Bid Bulletin #6

PROJECT: Kearney High School, Kearney, Nebraska
Bid Package #3
DATE: October 24, 2014

ADDENDUM #5

KEARNEY PUBLIC SCHOOLS KEARNEY NEW HIGH SCHOOL KEARNEY, NEBRASKA 1355

ENLARGED TRACK PLAN/DETAIL

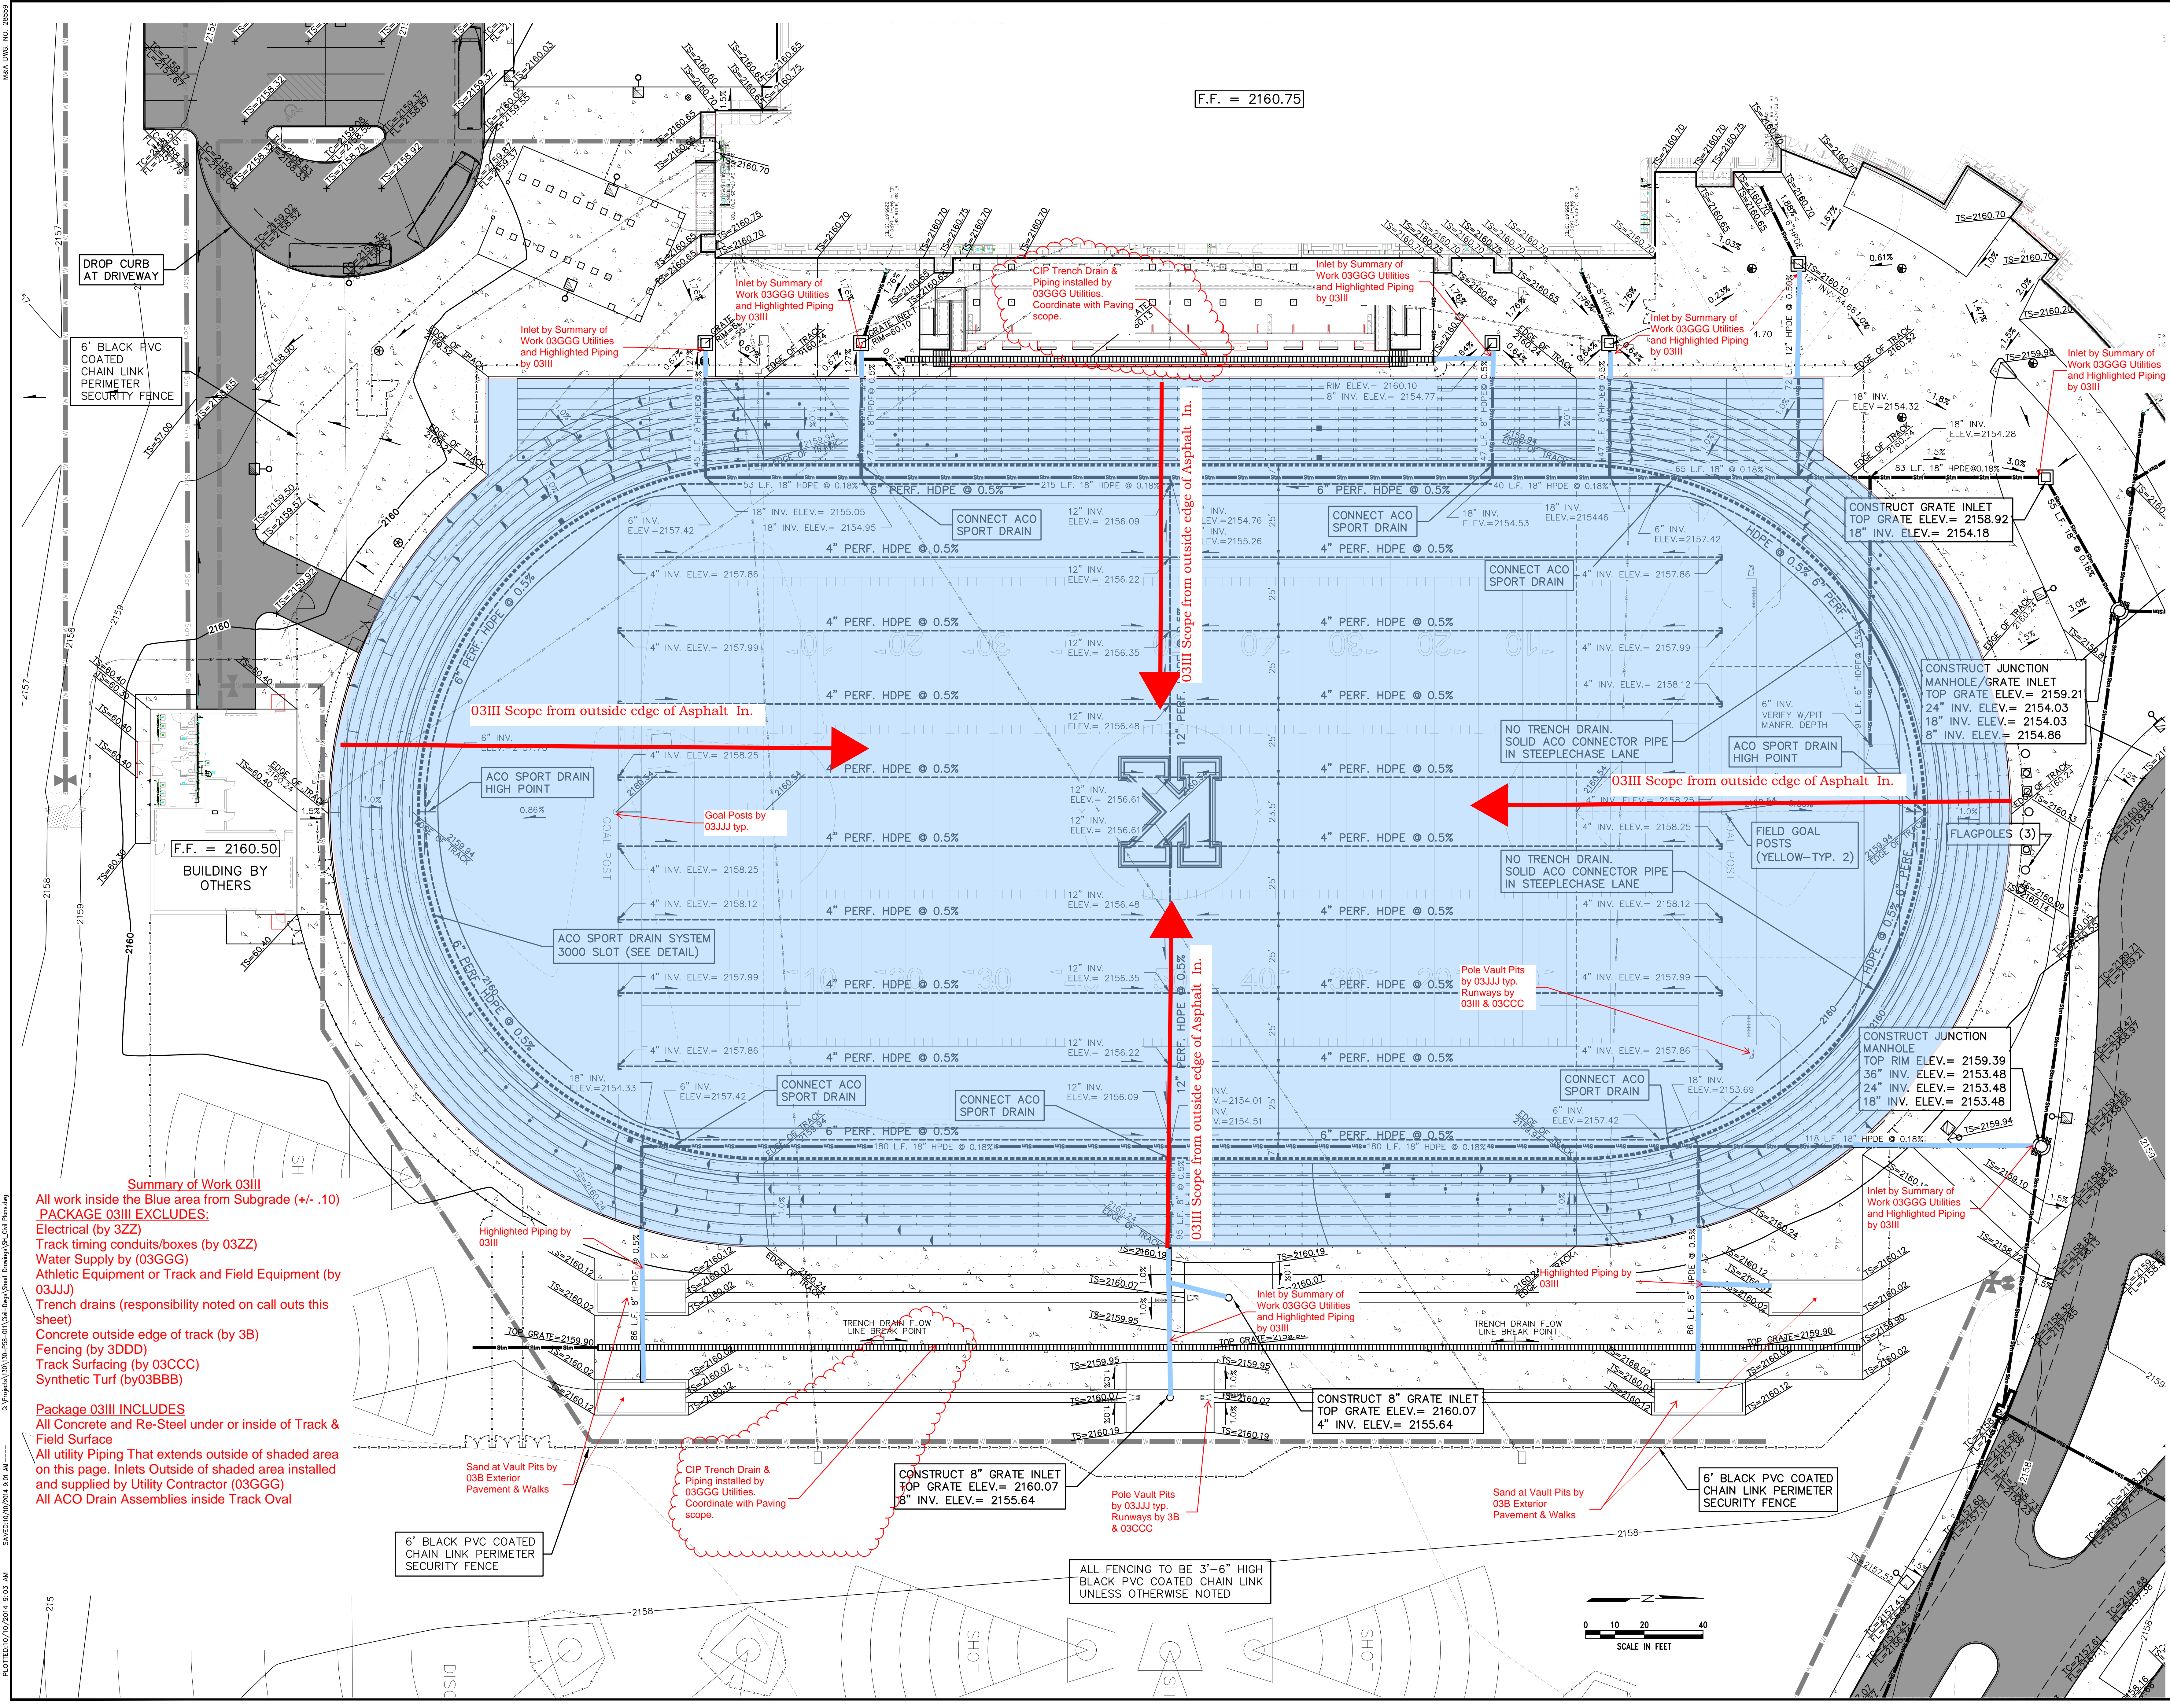
Item 5-2: See attached clarification sheet C6.0; Utility contractor needs to supply and install grated trench Drains. Coordinate with Exterior Paving Contractor.

Summary of Work 03III
All work inside the Blue area from Subgrade (+/- .10)
PACKAGE 03III EXCLUDES:
Electrical (by 3ZZ)
Track timing conduits/boxes (by 03ZZ)
Water Supply (by 03GGG)
Athletic Equipment or Track and Field Equipment (by 03JJJ)
Trench drains (responsibility noted on call outs this sheet)
Concrete outside edge of track (by 3B)
Fencing (by 3DDD)
Track Surfacing (by 03CCC)
Synthetic Turf (by 03BBB)

Package 03III INCLUDES
All Concrete and Re-Steel under or inside of Track & Field Surface
All utility Piping That extends outside of shaded area on this page. Inlets Outside of shaded area installed and supplied by Utility Contractor (03GGG)
All ACO Drain Assemblies inside Track Oval

C6.4

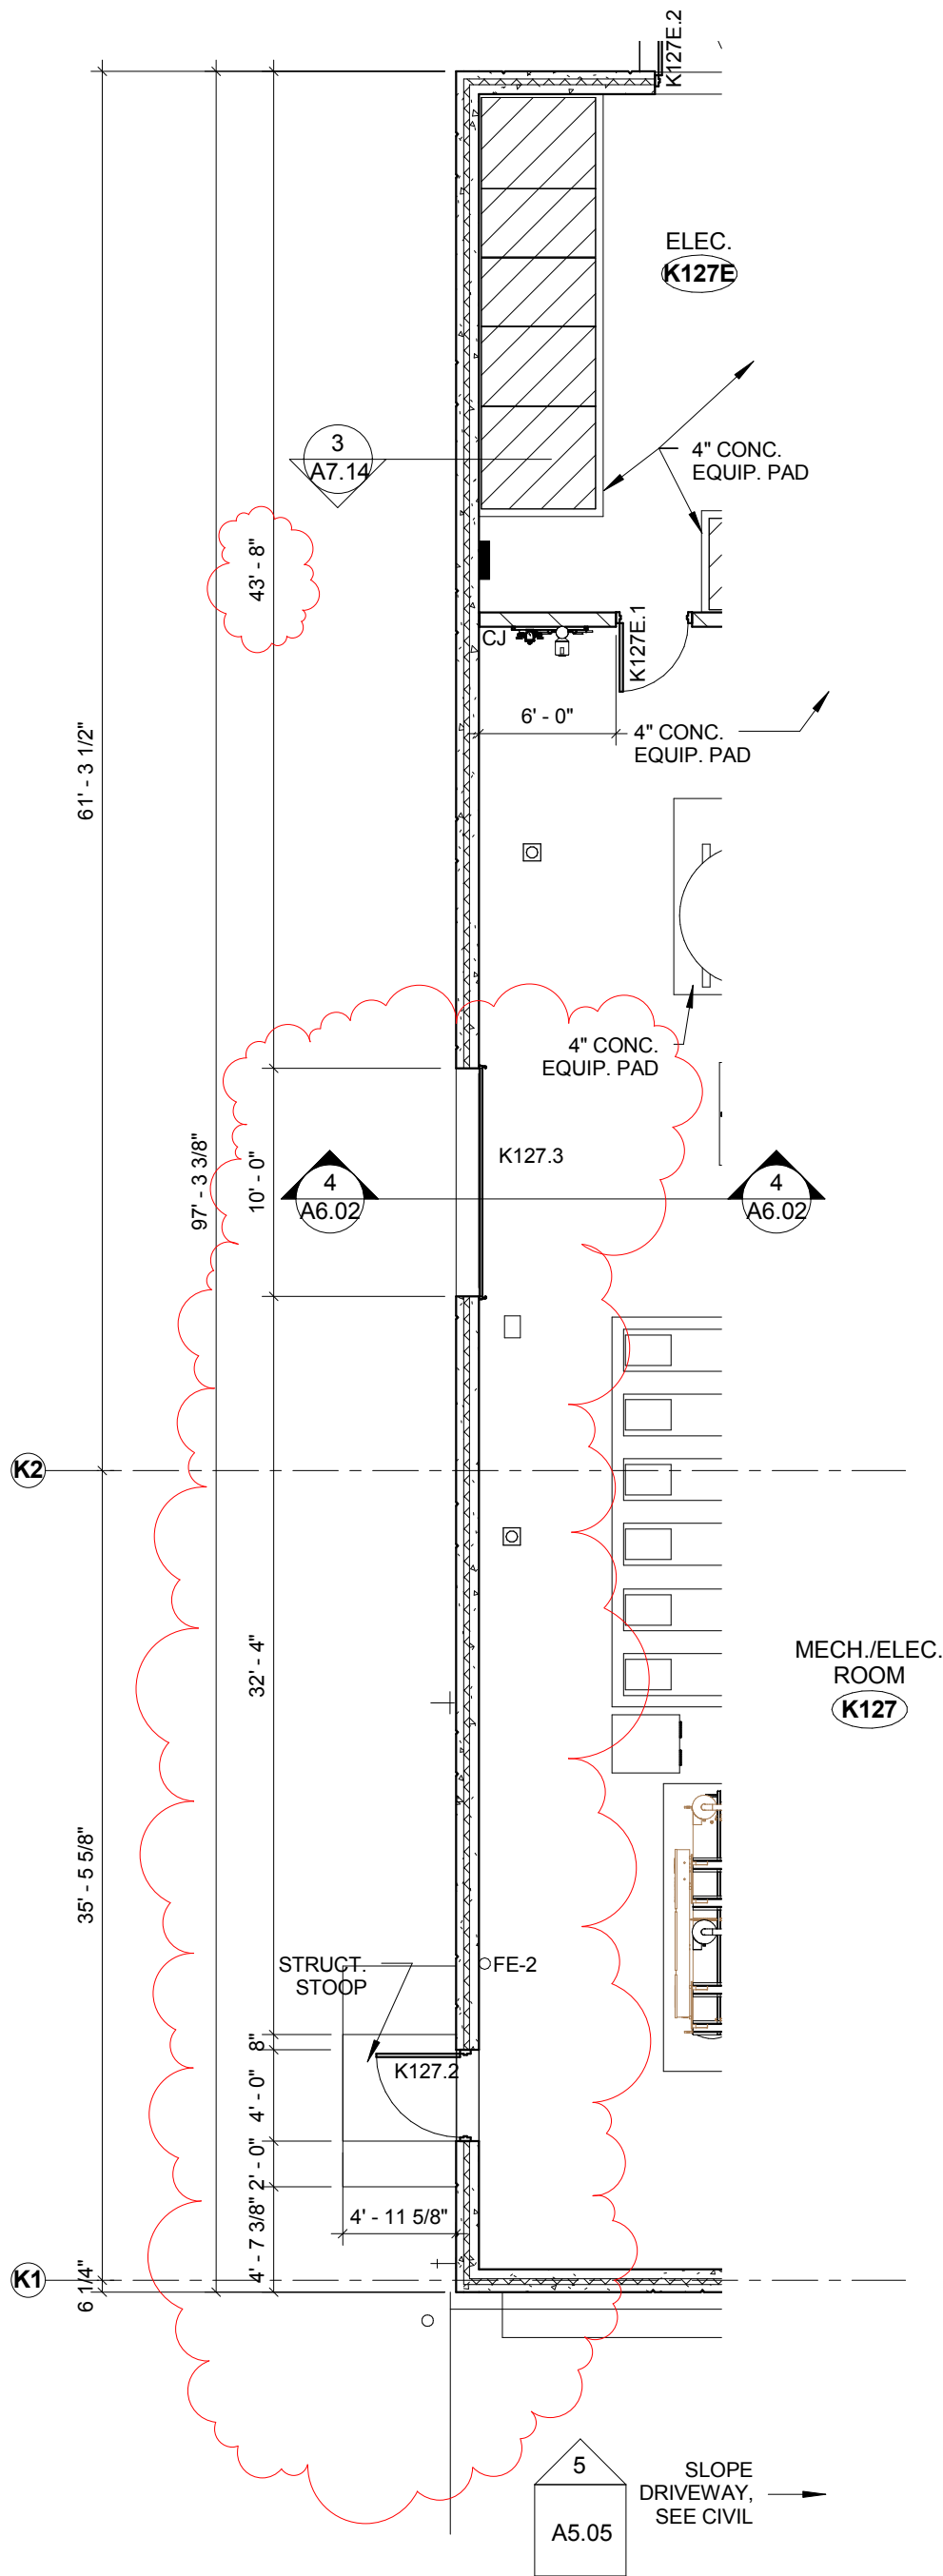
- Addendum #5 - #30 SHEET C6.4**
 Remove the soccer penalty kick line and replace with 9” diameter solid dot, as shown on the attached Detail entitled C6.4, attached to this Addendum.

N
1
FLOOR PLAN - FIRST FLOOR - AREA K
 AK112-1 SCALE: 1/8" = 1'-0"

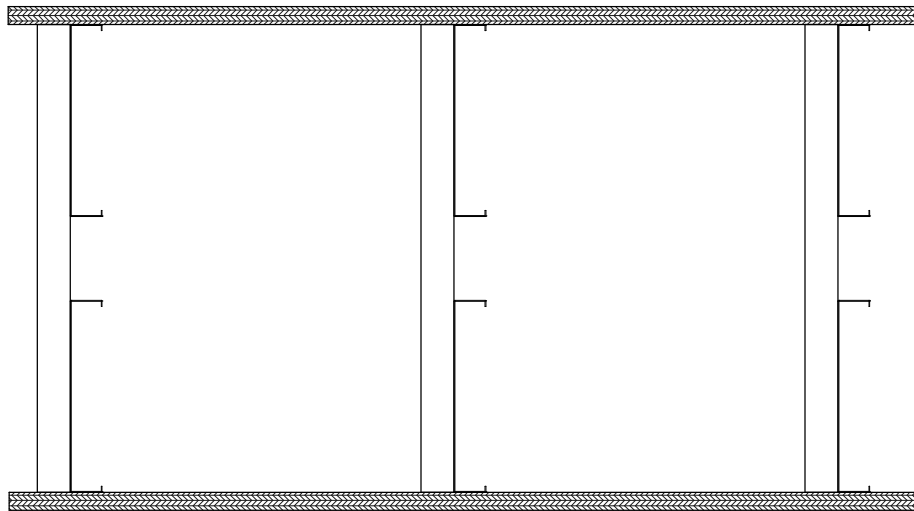
- Addendum #5 - #32 SHEET A1.12 – FLOOR PLAN – FIRST FLOOR – AREA K**
 1/A1.12 FLOOR PLAN – FIRST FLOOR – AREA K: Revise plan by adding a 10'-0" wide x 10'-0" tall, manually operated, overhead, insulated, sectional door and by modifying Door Opening No. K127.2 to be a 3'-8" x 7'-0" single leaf door in lieu of the pair of doors shown, and modify the stoop location and dimensions as shown on Attachment AK112-1, dated October 24, 2014.

TYP. PRECAST WALL PANEL CANOPY DETAIL - ADDENDUM 5

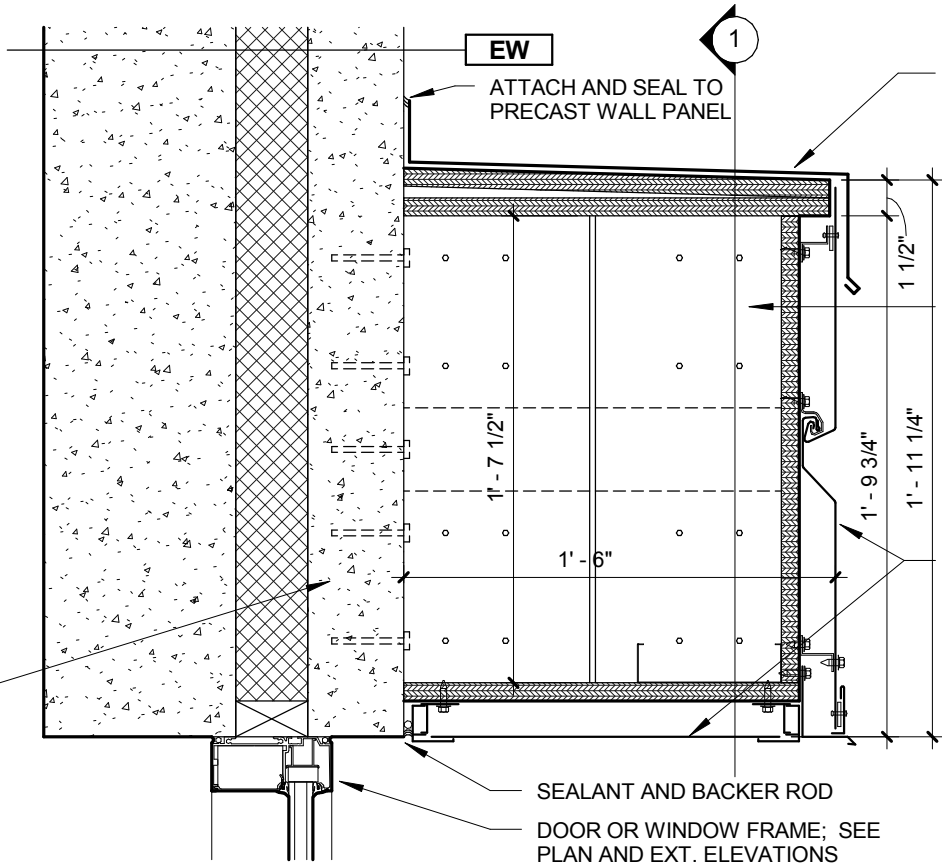
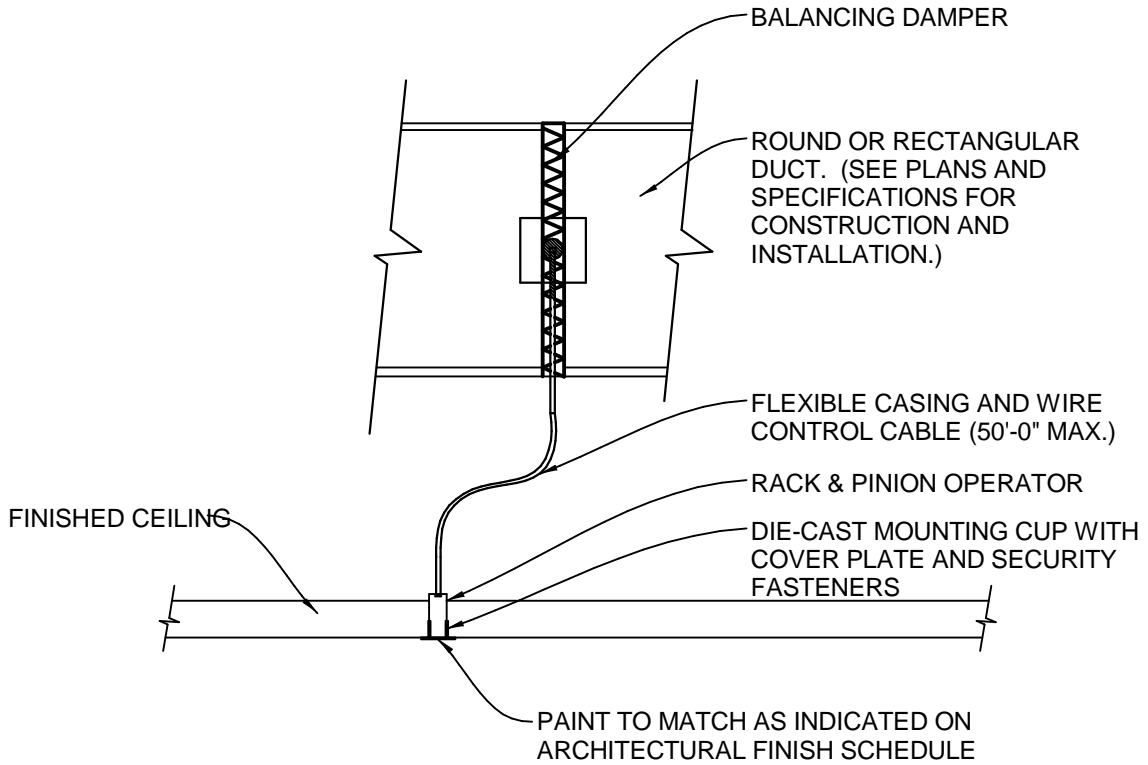
- Addendum #5 - #37 SHEET A7.14 – WALL SECTION – AREA K**
 14/A7.14 TYP PRECAST WALL PANEL CANOPY DETAIL: Revise this detail as shown on Attachment A5-A7.14, dated October 23, 2014.

8" COLD-FORMED METAL FRAMING, GAUGE THICKNESS AND STUD PROFILES TO BE DESIGNED BY COLD-FORMED FRAMING SUPPLIER'S ENGINEER

ATTACH COLD-FORMED METAL FRAMING TO WALL WITH SCREW ANCHOR CONNECTIONS BY COLD-FORMED SUPPLIER

EW
ATTACH AND SEAL TO PRECAST WALL PANEL

PREFINISHED METAL FLASHING ON ADHERED SINGLE-PLY RUBBERIZED WATERPROOF MEMBRANE (EXTEND MEMBRANE DOWN OVER FASCIA)

COLD-FORMED METAL FRAMING

FASCIA AND SOFFIT: METAL WALL PANEL ON ADHERED SINGLE-PLY RUBBERIZED WATERPROOF MEMBRANE (FASCIA ONLY) ON 5/8" EXT. WOOD SHEATHING ON GALV. 18 GA METAL STUDS AT 16" o.c.; ATTACH STUDS TO CHANNELS AND WALL PANEL WITH NON-CORROSIVE FASTENERS

SEALANT AND BACKER ROD
DOOR OR WINDOW FRAME; SEE PLAN AND EXT. ELEVATIONS

12 REMOTE VOLUME DAMPER
M4.2 NO SCALE

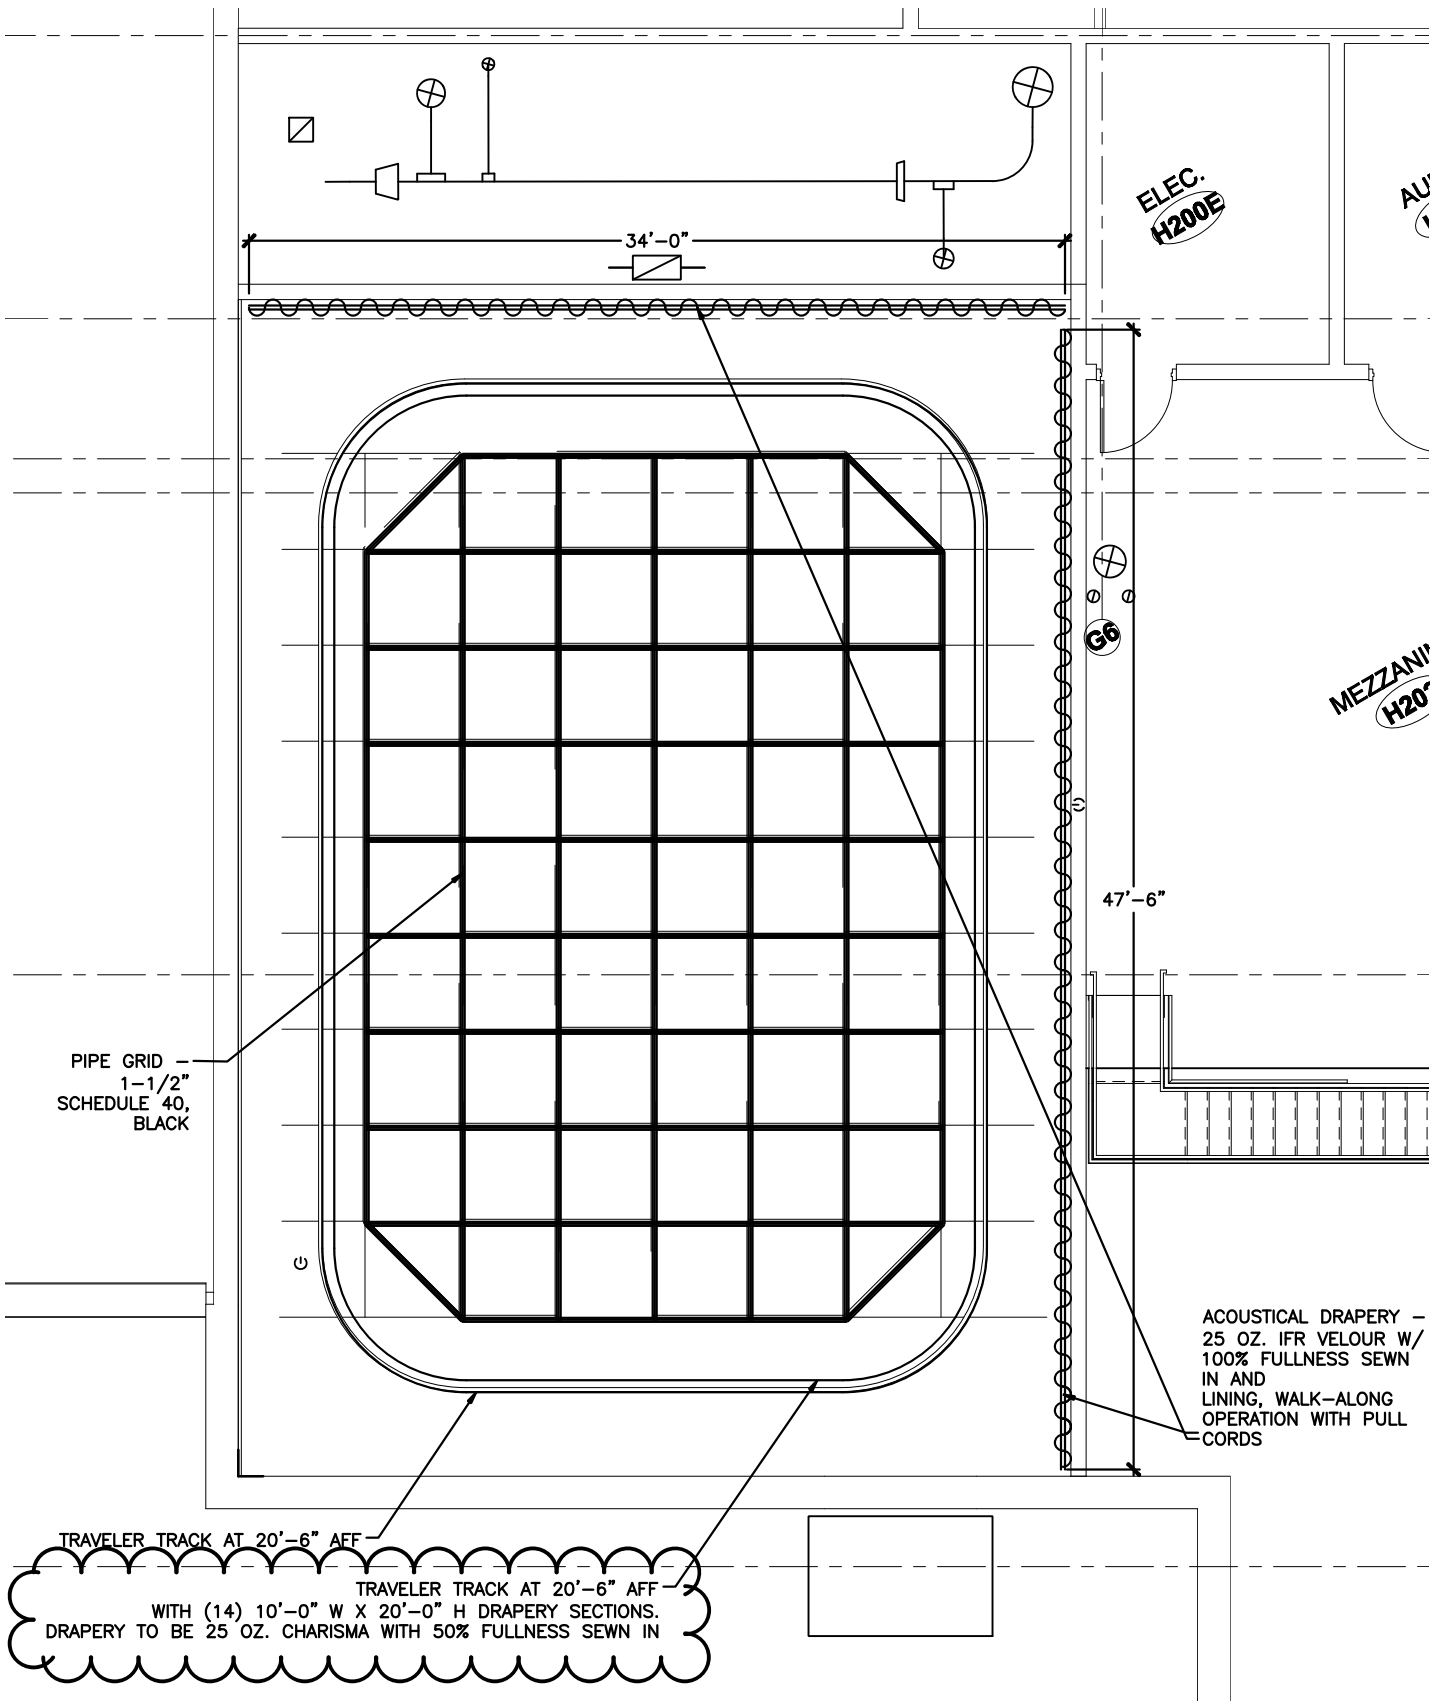
a. Delete Detail 12 and replace with attachment M4.2-1.
- Addendum #5 - #58 SHEETS ES0.1, ES0.2, ES0.3 – SITE ELECTRICAL UTILITIES PLAN(S)**
SITE ELECTRICAL UTILITIES PLAN NOTES: ALL OF THE SITE ELECTRICAL UTILITIES PLAN NOTES ARE FOUND ON SHEET ES0.4 IN LIEU OF THE SHEET ES0.1 INDICATED.
